Work Order ID 133611

Item Name: Crosstube Turning Detail

DRAWING NO. D407-667-145	TITLE CROSSTUBE ASS'Y (407 HIGH FWD)	REV. C	DART AEROSPACE LTD ENGINEERING ORDER		D.E.O. NO. D407-667-145-C-1	SHEET NO. SHEET 1 OF 1	SCALE NTS
DRAWN QP	CHECKED ASS	MFG. APPR. IB	APPROVED WD		DE APPR. H		
DATE 11.07.15	DATE 11.07.22	DATE 11.07.22	DATE 11/07/22		DATE 11.07.21

PURPOSE:

DETAIL P
BONDING STRAP INSTALLATION 2 PL

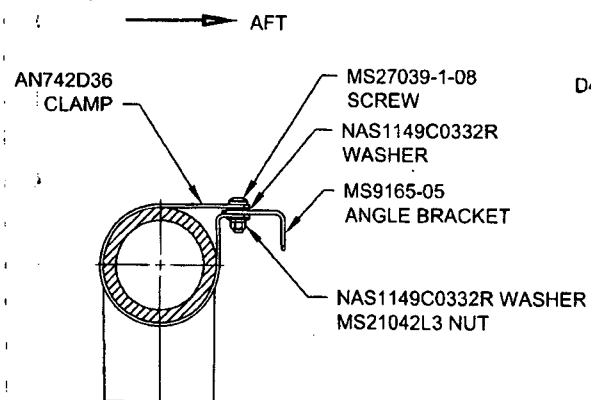
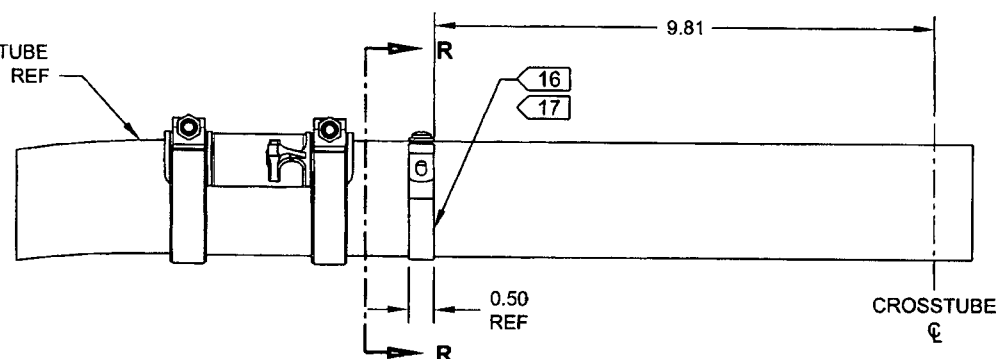
ADD ELECTRICAL GROUNDING STRAP

ADD

- 16) MASK AREA UNDER CLAMP PRIOR TO PAINTING
- 17) SEAL EDGES WHERE AN742D36 CLAMP MEETS WITH THE CROSSTUBE USING SIKAFLEX-241/-291 OR MIL-S-8802 CLASS B2 OR PROSEAL 890 SEALANT
- 18) PERFORM RESISTANCE CHECK TO ENSURE MAX RESISTANCE IS 10 MILLIOHMS

ITEM	QTY	PART NUMBER	DESCRIPTION
1	X	D407-667-145	CROSSTUBE ASSEMBLY (407 HIGH FWD)
10	2	AN742D36	CLAMP
11	2	MS9165-05	ANGLE BRACKET
12	2	MS21042L3	NUT (OR MS21042-3)
13	2	MS27039-1-08	SCREW
14	4	NAS1149C0332R	WASHER (OR AN960C10L)
